ALL WRITTEN PUBLIC COMMENTS RECEIVED

RE: federal fiscal years (FFYs) 2019–2023 Transportation Improvement Program (TIP) Development

5+2-Lane Surface Layout

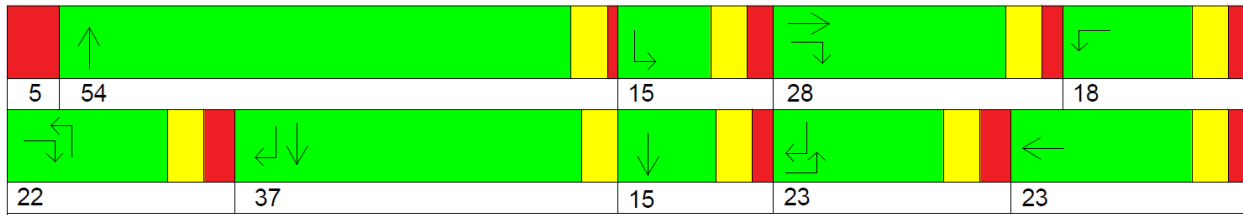
The 5+2-lane option is shown below. As shown in the sketch, it still leaves 48 to 49 ft on the neighborhood side for a linear park. In the two western corners, there are delta islands and slip lanes for right turns, because the very high right-turning volumes make it unsafe to allow right turns concurrently with a pedestrian crossing. However, the right turn slip lanes will not run “free;” they will be controlled by traffic signals.

Crossing Delay for Each of the 8 Crossings, a.m. peak hour, 5+2-lane Surface Option

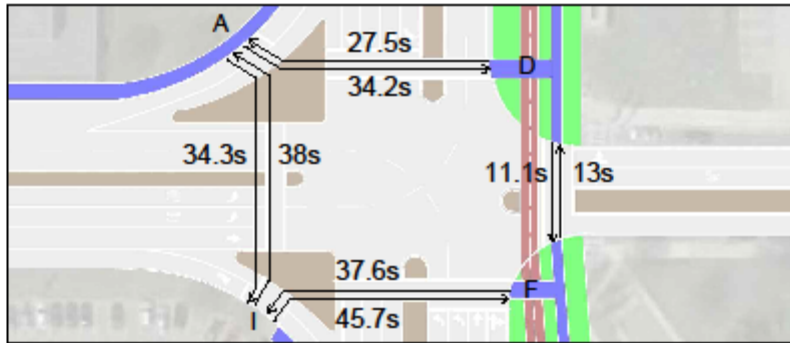
Detailed results on pedestrian crossings are shown in the following figure. Crossing times shown are for full crossings, and include any waiting that pedestrians might have to do at an intermediate island.

Smaller footprint layout that could be used if volumes with uninflated 2030 volumes

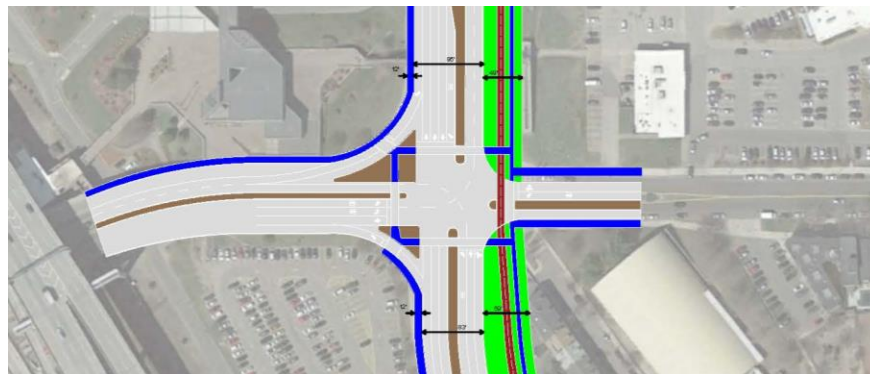
Omitting the questionable inflation factors mentioned earlier – and thus providing sufficient capacity for traffic projected in 2030 for the peak hour – it becomes possible to carry the traffic with a smaller footprint road, shown below. This option has only one left turn lane, and the linear park south of Austin Street is 11 ft wider. (North of Austin Street, the road footprint is unchanged.) In the a.m. peak, the most congested approach has a volume/capacity ratio of 0.94, and average delay is 52 s.

For Pedestrians: Crossings with Unacceptable Right-Turn Conflicts

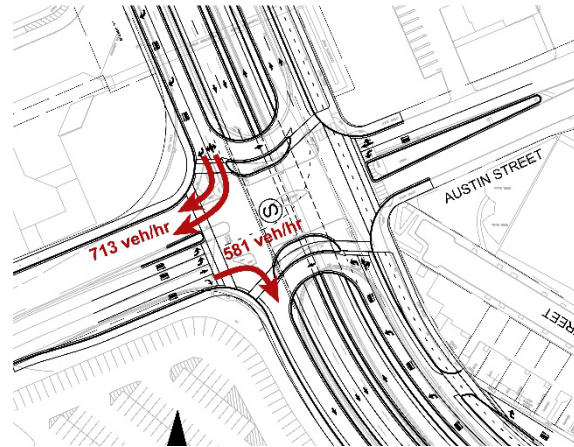
However, an analysis of the underpass option reveals exactly the opposite:

- Three of its four pedestrian crossings are unsafe – that is, they involve conflicts with right turning traffic with traffic volumes nearly triple the limit allowed by MassDOT.
- While cars that can use the underpass will fly through unimpeded, the surface streets will face delays of 2 to 2.5 minutes, with queues on the Rutherford Ave surface roads growing to almost 500 ft in both directions.
- Far from protecting the neighborhood from cut-through traffic, the underpass option will actually create serious congestion that gives traffic heading to the Gilmore Bridge an incentive to cut through the neighborhood.

The layout for the City's underpass option can be found at the project website. The City provided us with their proposed signal timing plan and capacity / delay analysis made using Synchro.

Lefts at compact intersections do not conflict.

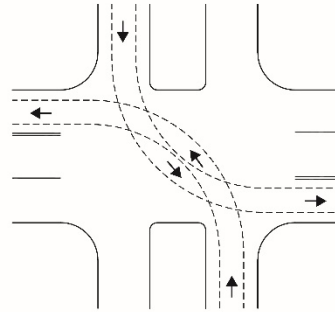
Second, ***an underpass creates a split intersection.*** The northbound and southbound surface roads will be separated from one another by about 60 ft. As a result, left turns cannot run concurrently, because they interlock, as illustrated in the figure below. The traffic signal plan is therefore forced to follow an arrangement called “split phasing,” in which each of the four legs has a turn in sequence. Split phasing is both less flexible and less efficient than the normal phase sequence in which opposite directions (e.g., northbound and southbound) run concurrently. One can observe this inefficiency at other intersections with underpasses, such as Mass Ave @ Commonwealth Ave and Mass Ave @ Huntington Ave in Boston, where traffic on the surface roads is often backed up.

Interlocking lefts at split intersections cannot run concurrently.

Split intersections result in interlocking lefts, which prevent left turns from running concurrently
